**Report: TAB REPORT
Function: Test, Adjust, & Balance
Date: 02/16/2026
Completed By: National TAB**

M'Lady Nissan Dealership (Crystal Lake, IL)

System/Unit: AHU/RTU

Asset: RTU1

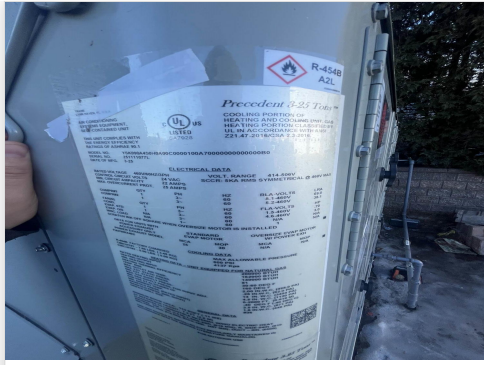
- [1] Unit is labeled RTU-2 but is RTU-1 on plans.
- [2] diffuser 17 is not installed.
- [3] dampers not installed on returns.

Asset: RTU3

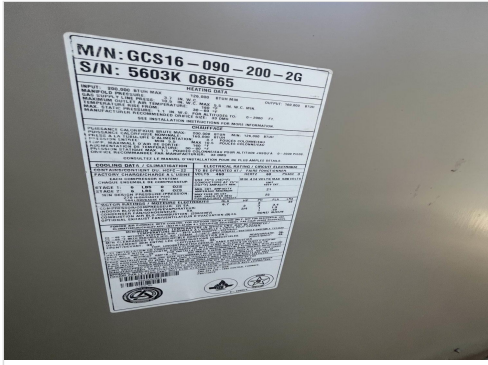
[1] Unable to proportionally balance low due to linear diffusers 1 thru 5 being high on airflow with no dampers installed to decrease airflow. showrrom 2x2 diffusers are all low on flow.

[2] Motor sheave is seized, unable to adjust sheave to increase airflow. Airflow is at 2752/3000 CFM 91.73%

[3] Can not locate controller for OA dampers to be adjusted. could not properly set OA. Reported as is.

Asset: RTU4

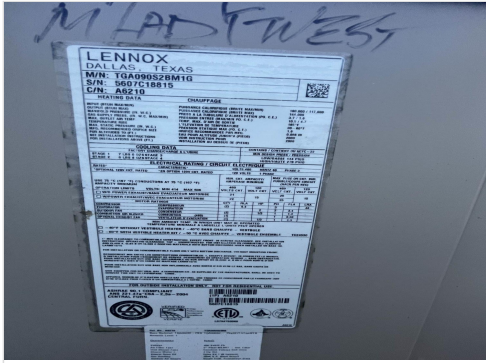
Return air reduced proportionally to accommodate outside air.
 Unit is very low on flow and only runs when jumpered to blower only. See issue regarding mechanical inspection.
 Due to low flow could not balance as this would result in further airflow loss.
 Could not set OA due to damper not functioning. Damper is closed.

Asset: RTU5

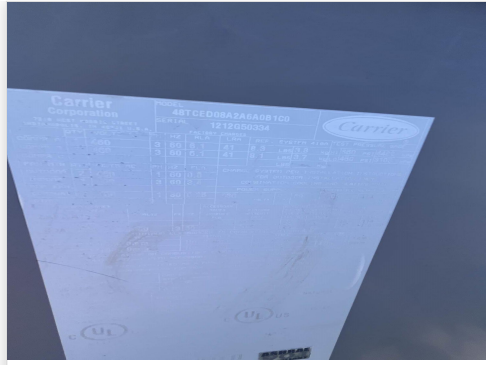
- Return air reduced proportionally to accommodate outside air.
- OA damper manually set at 0.75" open
- [1] could not locate dampers for Returns.

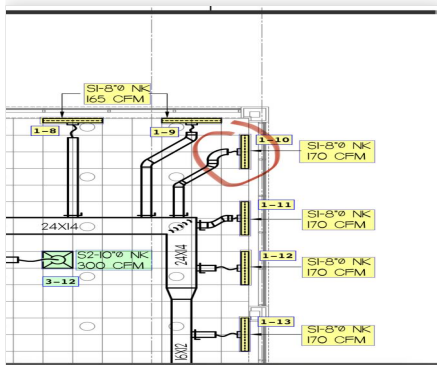
Issue Name : Diffuser 1-10 missing damper
Description : Diffuser 1-10 is missing a damper, diffuser is high on flow. Unable to balance properly
Created By : National TAB **Assigned To :** National TAB - Stephan Gabbert
Status : Open
Priority : Urgent **Asset Tag :**
Originated Date : 02/12/2026 - Dylan Crisman - National TAB

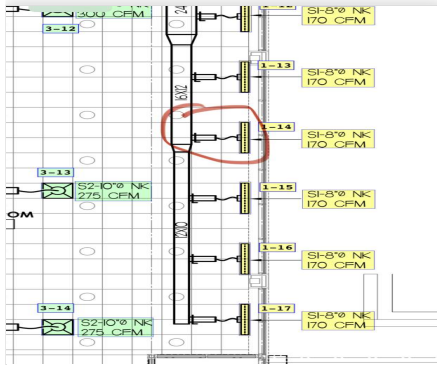
Issue Name : Diffuser 1-14 missing damper.
Description : Missing damper on Diffuser 1-14 for RTU-1 on showroom linear diffuser. Diffuser is high on flow. Unable to balance properly
Created By : National TAB **Assigned To :** National TAB - Dylan Crisman
Status : Open
Priority : Urgent **Asset Tag :**
Originated Date : 02/12/2026 - Dylan Crisman - National TAB

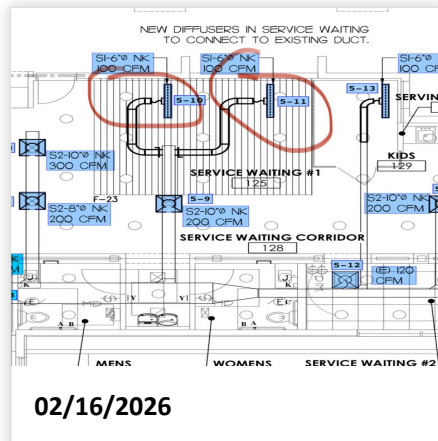
Issue Name : Diffuser 5-11/5-10 no airflow
Description : Diffusers 5-11/5-12 linear above the service waiting room were receiving no airflow, due to hard ceiling we were unable to determine direct root cause. Recommend mechanical inspection.
Created By : National TAB **Assigned To :** National TAB - Stephan Gabbert
Status : Open
Priority : Urgent **Asset Tag :**
Originated Date : 02/16/2026 - Dylan Crisman - National TAB

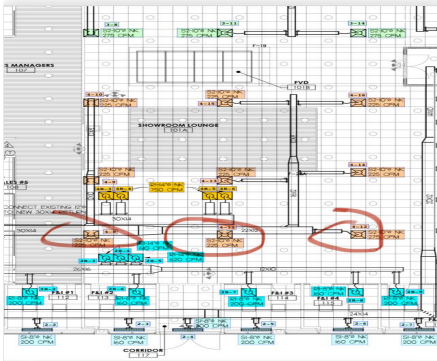
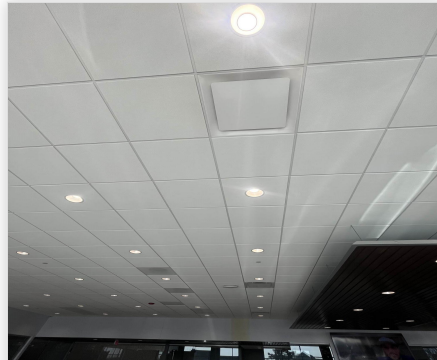
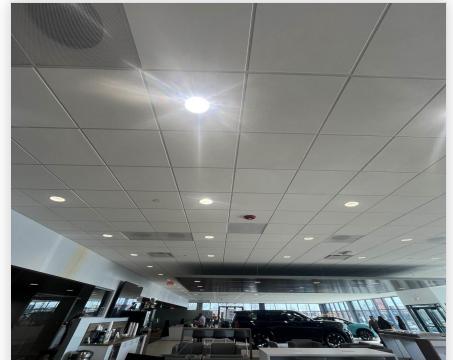
Issue Name : Diffusers on RTU-4 8-11-12 missing
Description : Diffusers 4-8,4-11,4-12 are missing on site, noted in plans to show where they should be installed.
Created By : National TAB **Assigned To :** National TAB - Dylan Crisman
Status : Open
Priority : **Urgent** **Asset Tag :**
Originated Date : 02/16/2026 - Dylan Crisman - National TAB

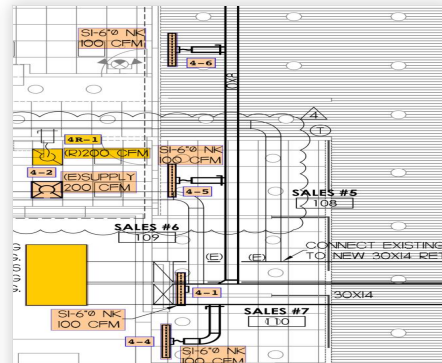
Issue Name : No airflow Diffuser 4-5
Description : Diffuser 4-5 is getting no airflow, unable to get a good look above ceiling to see if duct is disconnected or damper is fully closed at takeoff, blades at the face of the diffuser are fully open.
Created By : National TAB **Assigned To :** National TAB - Dylan Crisman
Status : Open
Priority : Urgent **Asset Tag :**
Originated Date : 02/16/2026 - Dylan Crisman - National TAB

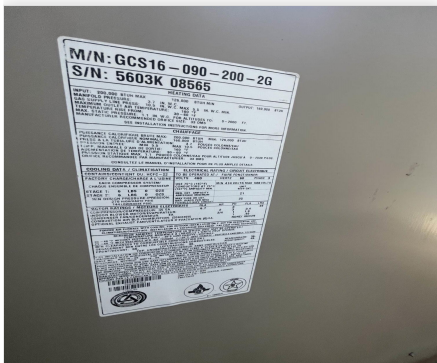
Issue Name : RTU-3 motor sheave seized
Description : RTU-3 motor sheave is seized. Rusted shut, and hex set keys on pulley are stripped. Unable to free to make speed adjustment on unit. Unit is at 92% of design airflow 2752/3000CFM.

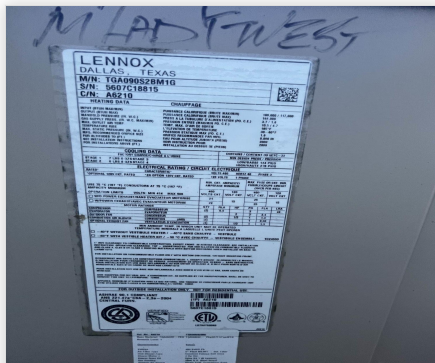
Issue Name : RTU-4 not operational
Description : RTU-4 is not operational at time of TAB. When commanded to run via thermostat or jumpering at unit the thermostat displays an alarm “no power from heat / cool System”
Created By : National TAB **Assigned To :** National TAB - Dylan Crisman
Status : Open
Priority : Urgent **Asset Tag :**
Originated Date : 02/12/2026 - Dylan Crisman - National TAB

- **02/16/2026 National TAB - Dylan Crisman**
 - RTU-4 was able to be Jumpered to run in blower only to get an airflow reading, the unit was very low on flow. Suspected to be because it couldn't be ran in full cool/full heat. gas was turned off and unit would not run heating or cooling, mechanical is unaware of any issues with this unit as they did not work on it and advised to contact the owners of Nissan to further diagnose.
